<b>HYUNDAI</b> <b>Technical Service Bulletin</b>	GROUP <b>BODY ELECTRICAL</b>	NUMBER <b>25-BE-018H</b>
	DATE <b>SEPTEMBER 2025</b>	MODEL(S) <b>VENUE (QX)</b>
<b>SUBJECT:</b> INOPERATIVE HORN ASSEMBLY REPLACEMENT (WARRANTY EXTENSION TXXU)

**This TSB supersedes 24-BE-018H to revise the Applicable Vehicles, Parts Information, Warranty Information, and Service Procedure sections.**

**Description:** Certain Venue (QX) vehicles may have an inoperable horn that may be caused by foreign substances causing internal parts to oxidize.

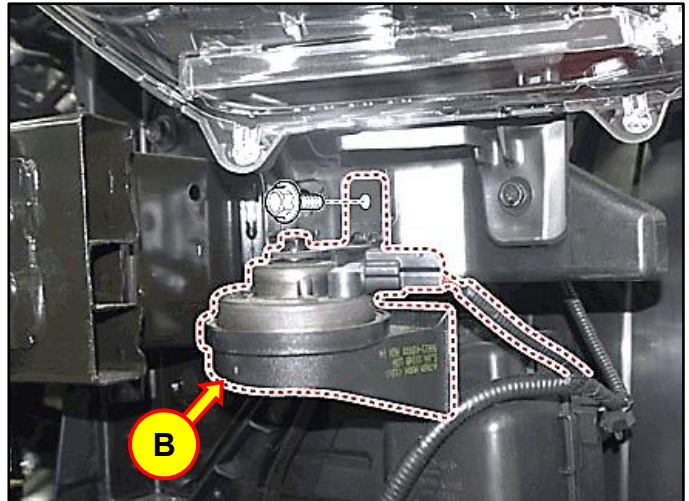
5. Refer to the shop manual to remove the horn (B) by disconnecting the horn connector and removing the mounting bolt:
- **Body Electrical System > Horn > Repair procedure**

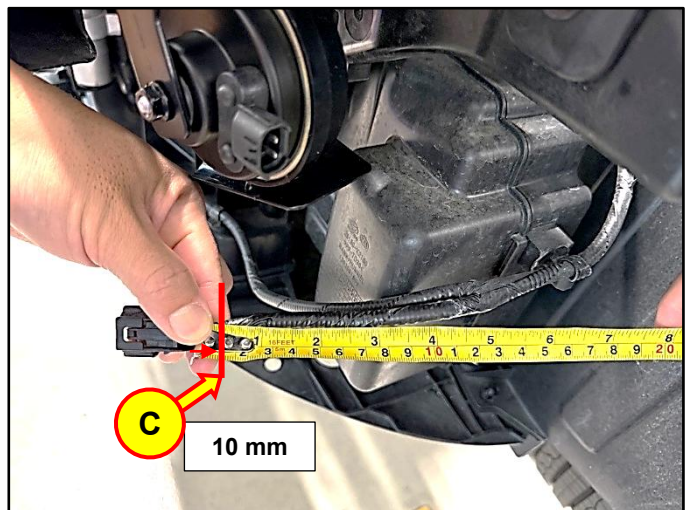
6. Wrap the PVC Electrical Tape **10 mm** (~0.4 inches) (C) from the end of the female connector.

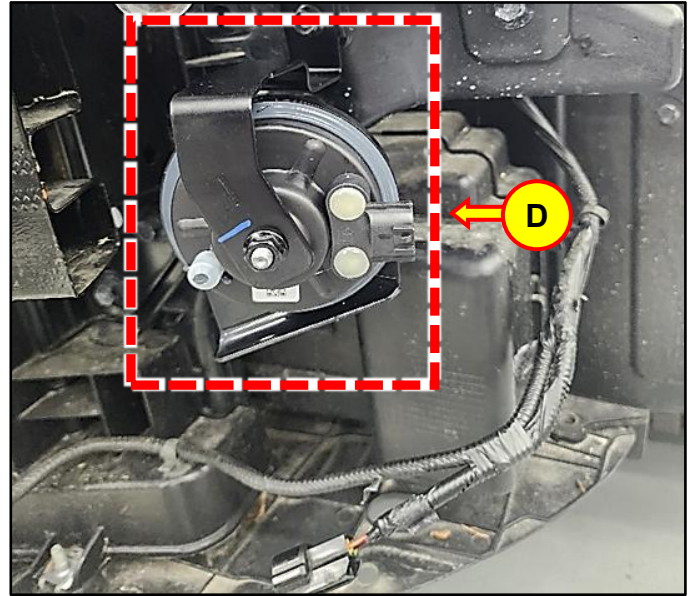
7. Install the new horn (D).

The supplied horn will be **VERTICALLY MOUNTED**.

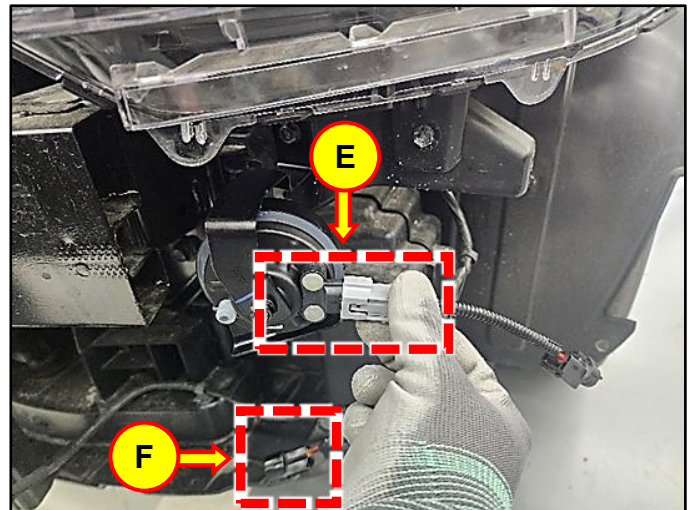
8. Connect the extension wire to the horn's connector (E) and the front wiring harness connector (F).

Use the supplied extension cable to connect to the horn.
